RE: JMC Project 15024
 ARB Amendment Golden Vista
 Meadow Hill Rd
 Town of Newburgh, NY
 Town of Newburgh Project No. 99-33

MEMORANDUM

Date: January 20, 2016
 To: Town of Newburgh -- Planning Board
 From: Bruce Englebaugh, AIA
 Project: DRA Meadow Hill, LLC; "Golden Vista", Newburgh, NY
 Subject: Summary changes made to the architectural concept after site plan approval.

12 UNIT - ELEVATION COMPARISON

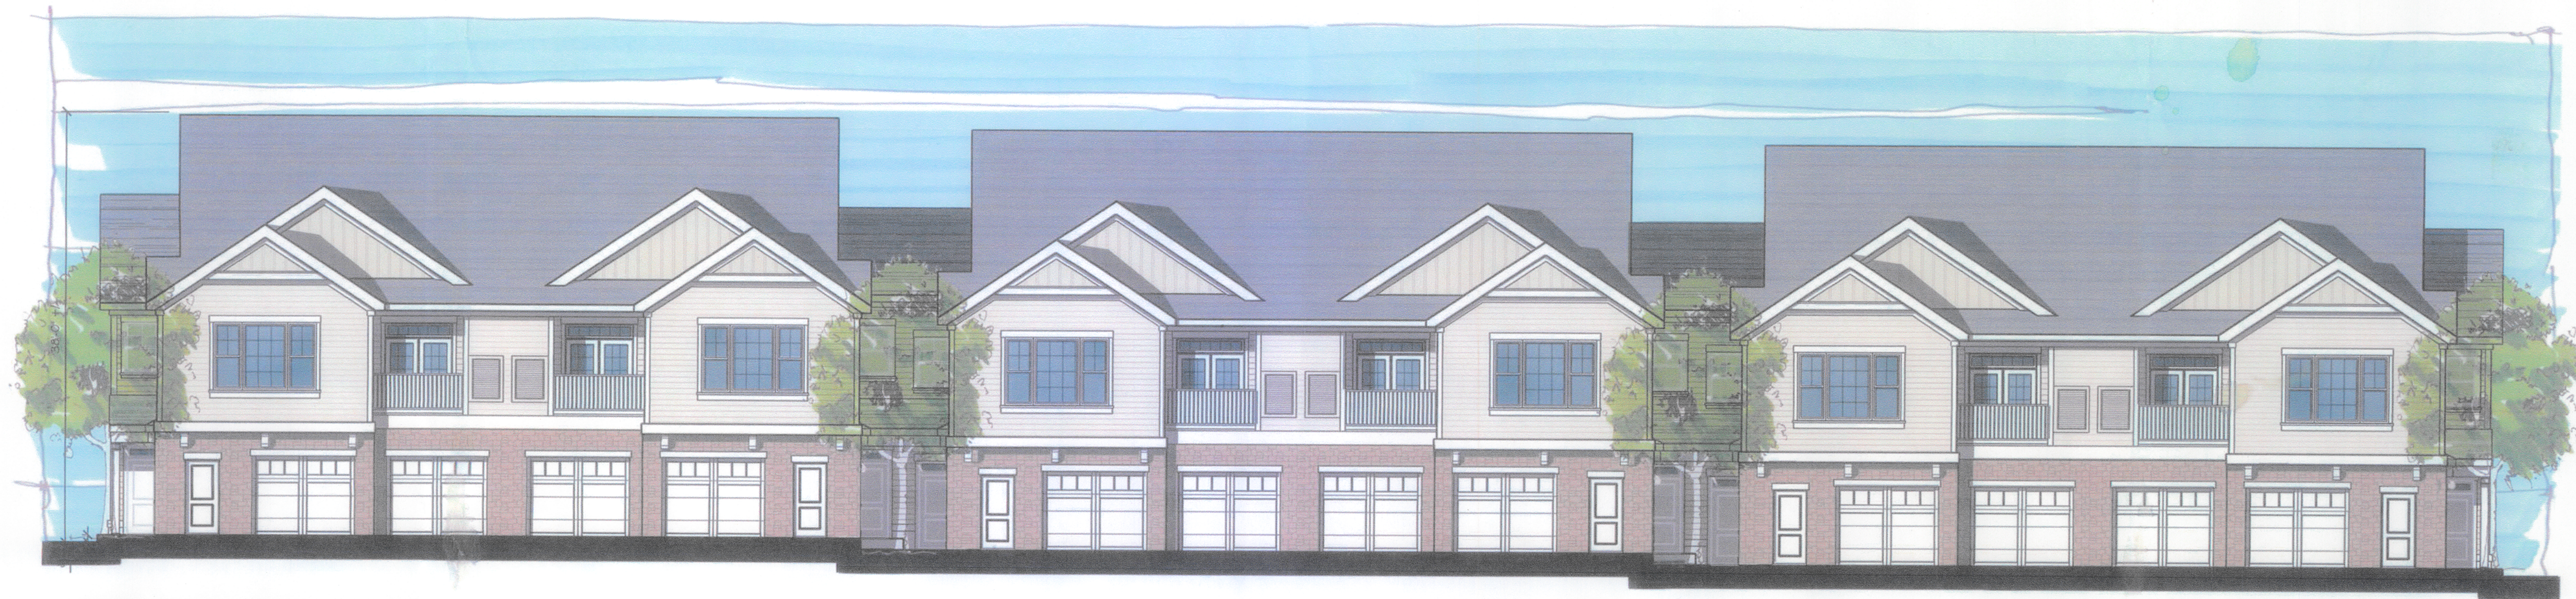
3. Roof-line: The roof on the approved scheme had gable ends, the new M&W scheme proposes hip roof for the primary roof and gable ends for accents. The hip roof concept helps to visually break down the scale at each end of the building. The hip roof also increases the amount of daylight and air circulation within the entrance courtyards.

8. Window groupings were adjusted slightly to better work with furniture within the units.
9. Exterior colors: In general the exterior color scheme was "darkened" slightly.

18 UNIT - ELEVATION COMPARISON

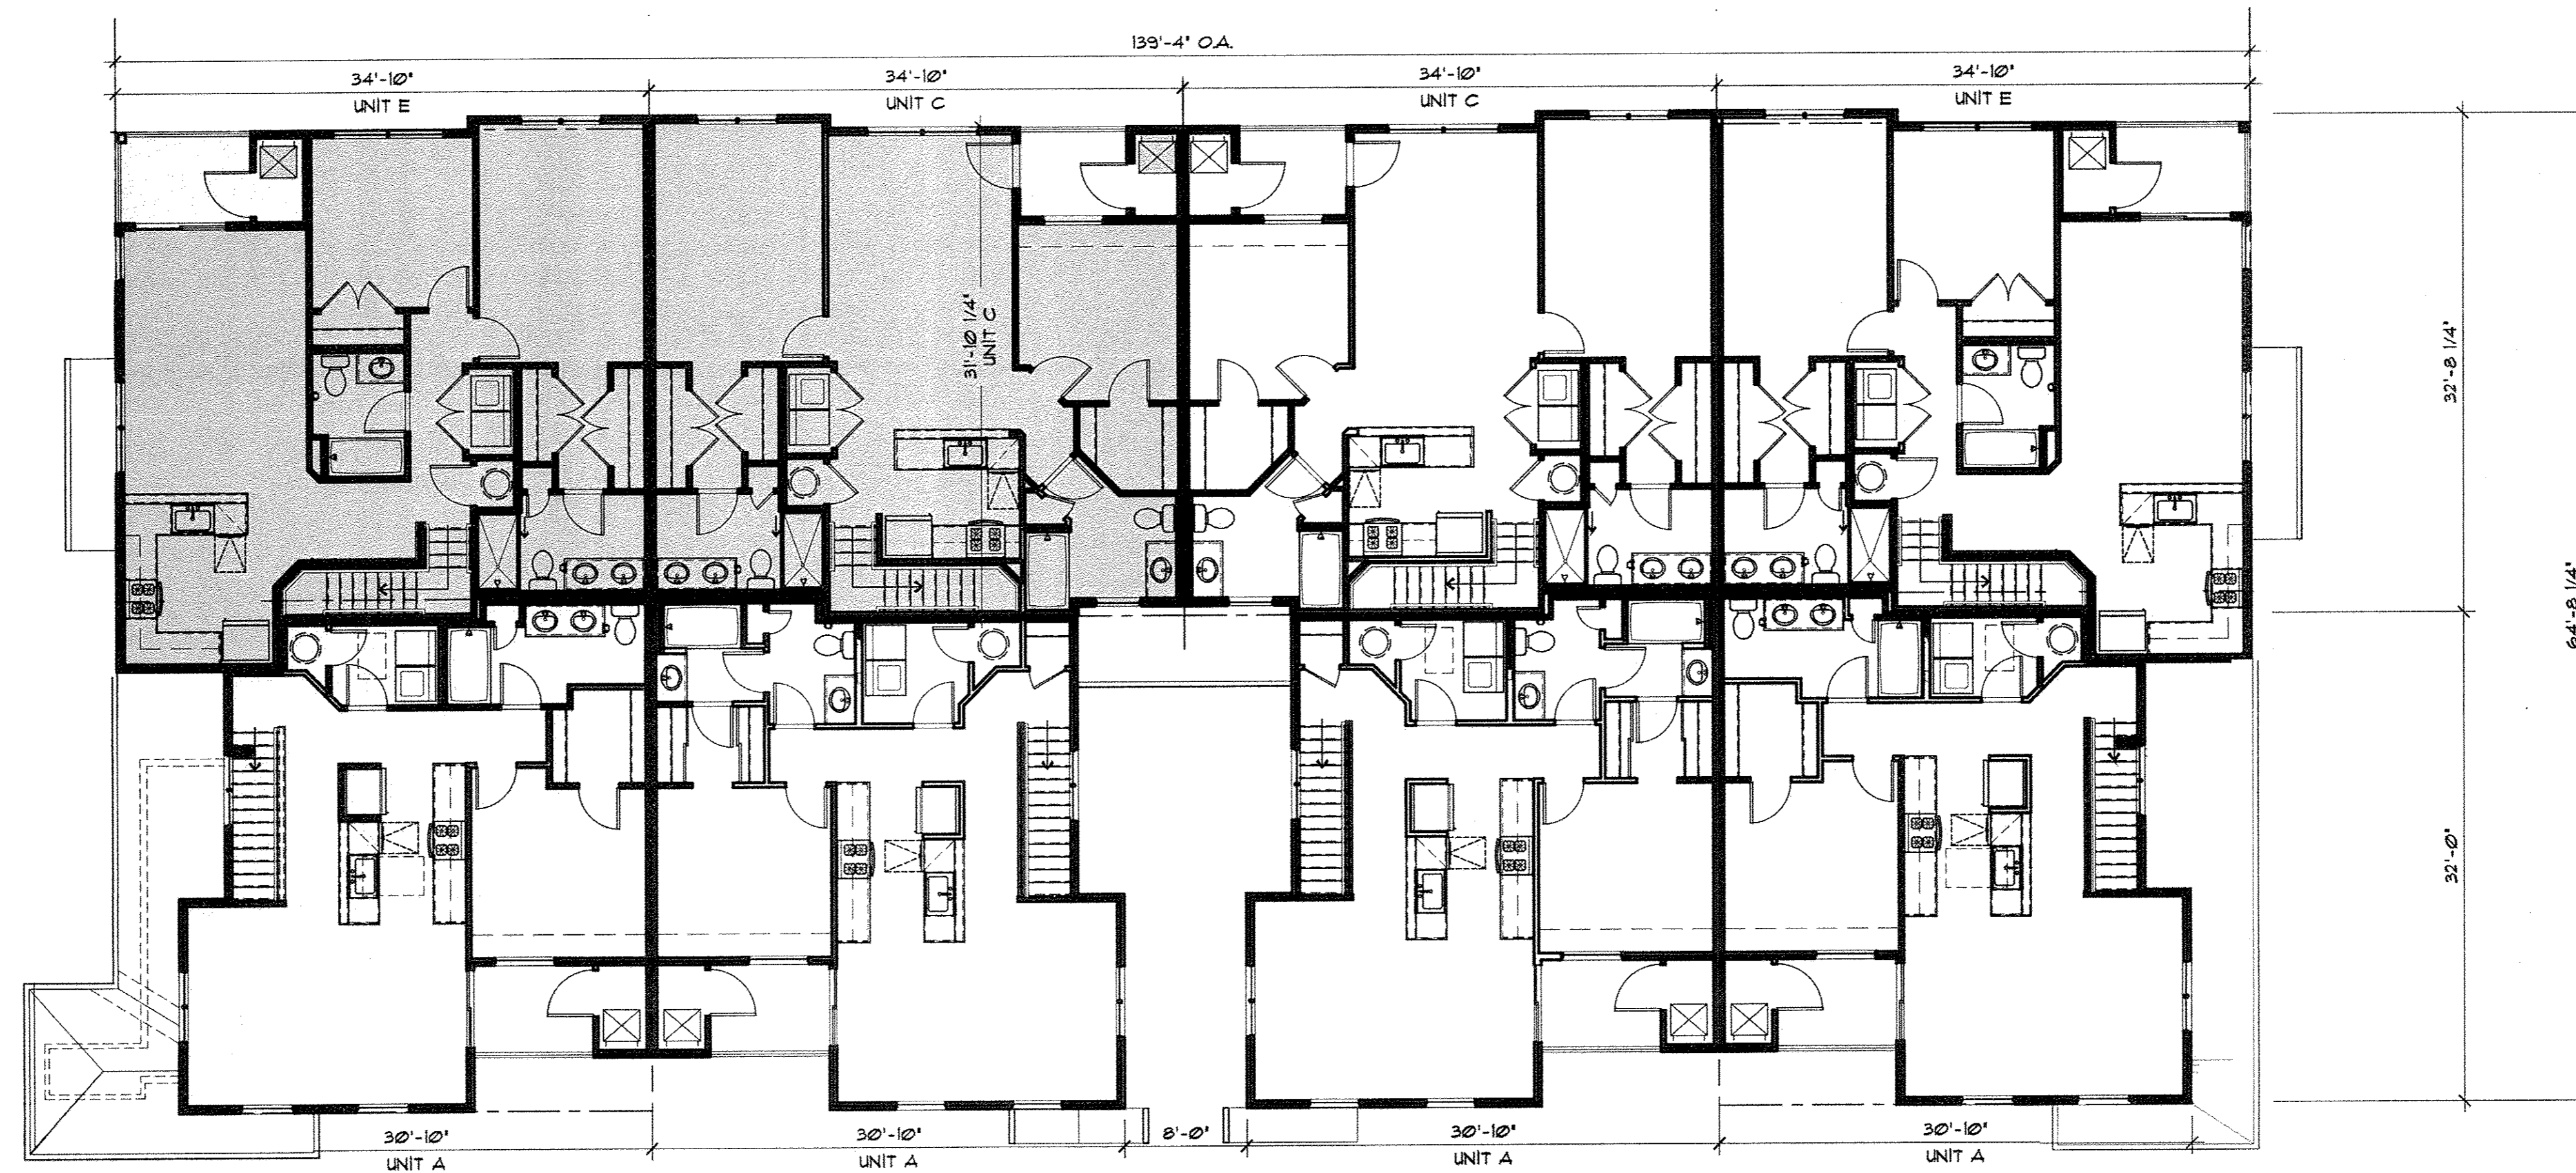
6. Provisions for resident trash storage were added. Areas for sprinkler closets and meters were added.
7. Pent roofs and/or canopies were added over the front door entrances to protect residents from inclement weather. This refinement also improves the visual aesthetics of individual front door areas and the overall building façade.
